TEXAS UTILITIES GENERATING COMPANY
SKYWAY TOWER * 400 NORTH OLIVE STREET, L.B. 81 * DALLAS, TEXAS 75201

June 22, 1984

TXX-4201

COMANCHE PEAK STEAM ELECTRIC STATION
UNITS 1 and 2
PROTECTIVE COATING ALLEGATIONS TRANSMITTED
BY LETTER OF MAY 18, 1984
FILE NO. 906.1

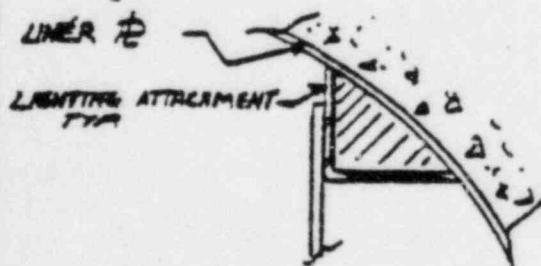
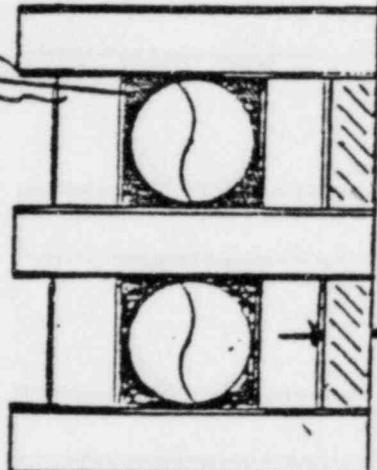
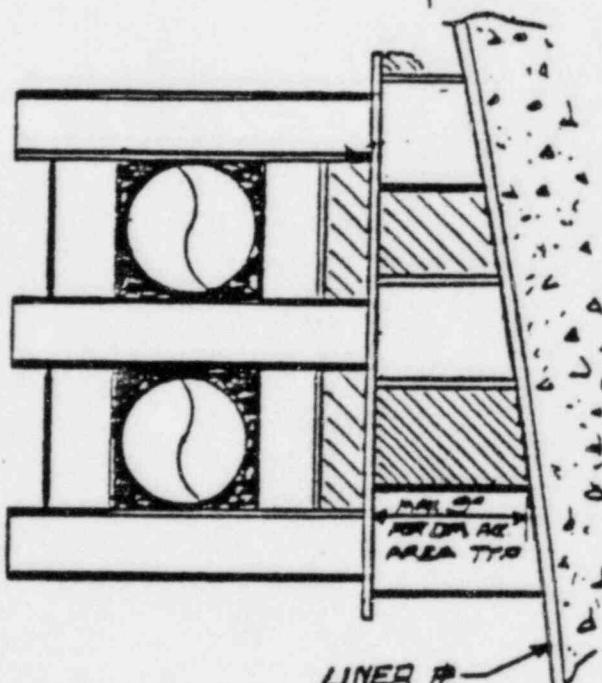
In Reactor Building Unit 1 & 2, pipe supports & various electrical and equipment supports have areas which due to installation configuration of the supports or equipment an SSPC-SP10 or equal surface preparation cannot be achieved. This SSPC-SP10 or equal surface preparation cannot be achieved due to limited access to the specific area or inaccessibility per paragraph 1.1b. Request clarification of coating in these areas.

SOLUTION: Items and/or areas which are not inaccessible per paragraph 1.1b of AS-31, but due to the installation configuration of the support or item, the required SSPC-SP10 surface preparation cannot be met shall be considered as limited access areas. Typical limited access areas are as shown on the attached drawing.

All steel installed in the Reactor Buildings which is governed under AS-31 coating requirements is, as a minimum, shop primed prior to installation. The non previously AS-31 primed steel is therefore, limited primarily to weld and field cut locations.

In limited access areas, SSPC-SP10 or equal should be maintained if possible, however, SSPC-SP-6 or equal surface preparation shall be the minimum acceptable.

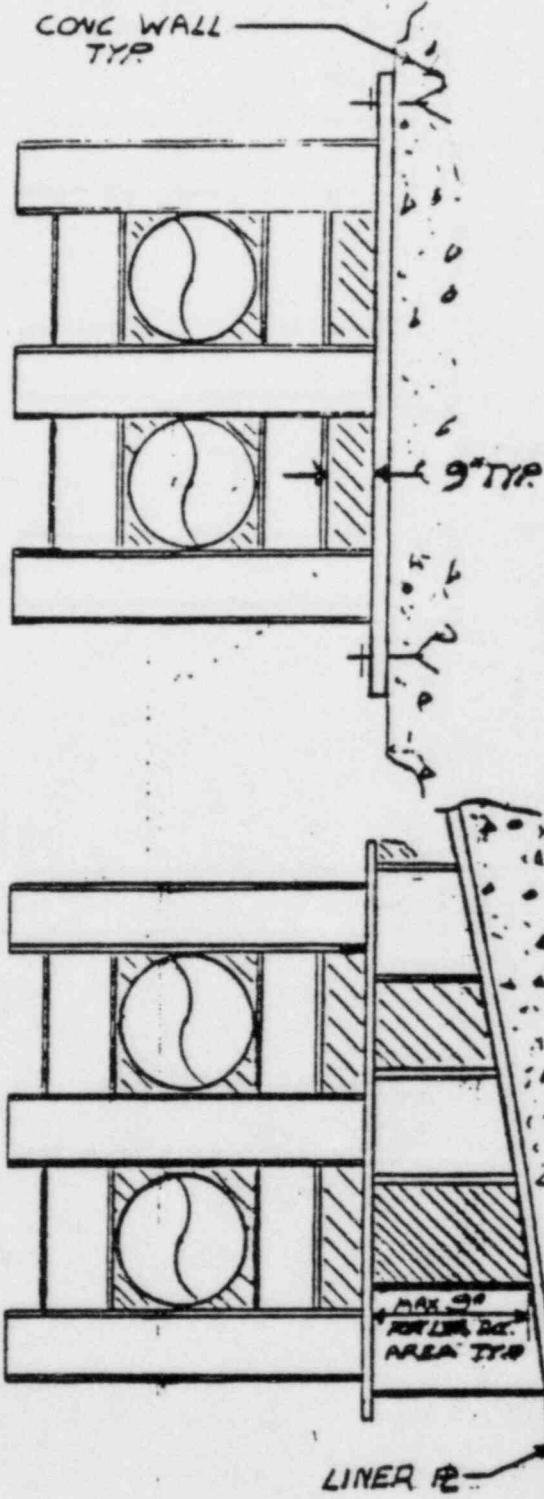
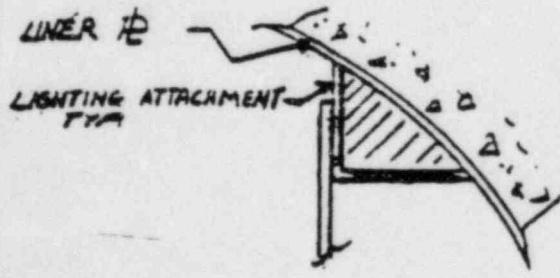
The SSPC-SP10 or equal surface preparation cannot be met because of limited access to the specific area. Typical of these areas are shown on the attached drawing to this document as hatched areas. Request clarification on coating of these areas.

Solution: Items and/or areas which are not inaccessible per paragraph 1.1b of the above applicable specification, but due to the installation configuration of the support or item, the required SSPC-SP-10 or equal surface preparation cannot be met, shall be considered as limited access areas. Typeical limited access areas shall be areas as shown on the attached drawing.

All steel installed in the Reactor Buildings which is to be coated under AS-31 requirements is, as a minimum, shop primed prior to installation. Therefore, the non previously AS-31 primed steel surface area is limited primarily to weld and field cut locations.

If possible, surface preparation of SSPC-SP-10 or equal should be maintained in limited access areas; however, as a minimum, SSPC-SP-6 or equal surface preparation shall be maintained.

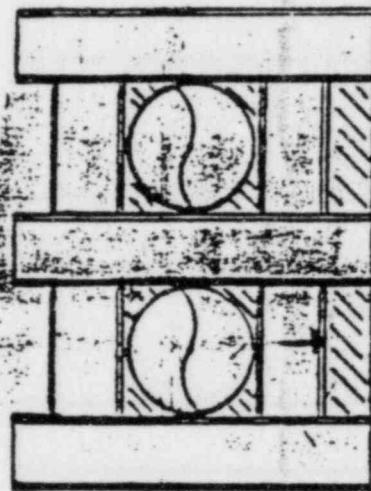
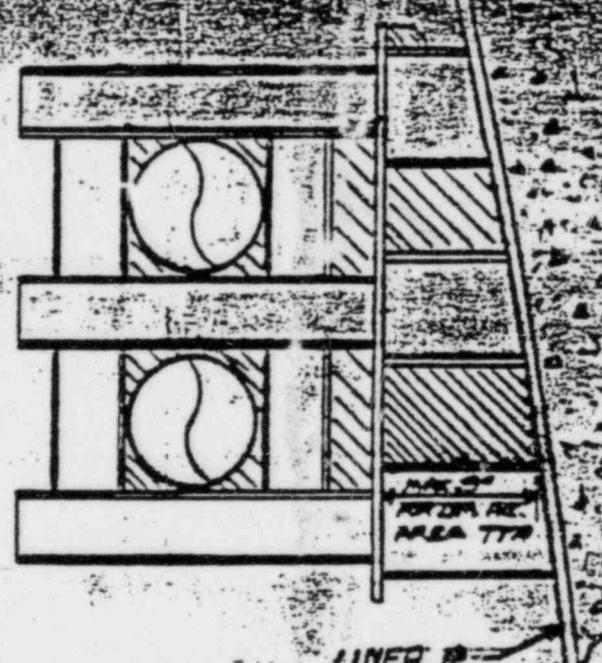
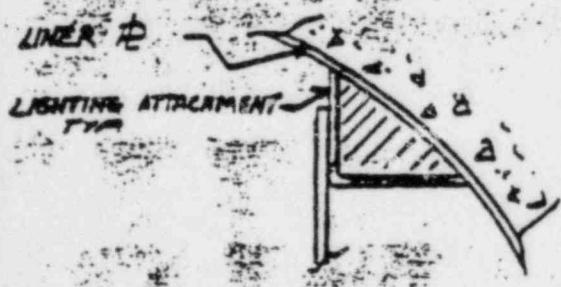
In Reactor Building Unit 1 & 2, pipe supports and various electrical and equipment supports have areas which, due to the installation configuration of the support or equipment, an SSPC-SP-10 or equivalent surface preparation cannot be achieved.

The SSPC-SP10 or equal surface preparation cannot be met because of limited access to the specific area. Typical of these areas are shown on the attached drawing to this document as hatched areas. Request clarification on coating of these areas.

Solution: Items and/or areas which are not inaccessible per paragraph 1.1b of the above applicable specification, but due to the installation configuration of the support or item, the required SSPC-SP-10 or equal surface preparation cannot be met, shall be considered as limited access areas. Typical limited access areas shall be areas as shown on the attached drawing.

All steel installed in the Reactor Buildings which is to be coated under AS-31 requirements is, as a minimum, shop primed prior to installation. Therefore, the non previously AS-31 primed steel surface area is limited primarily to weld and field cut locations.
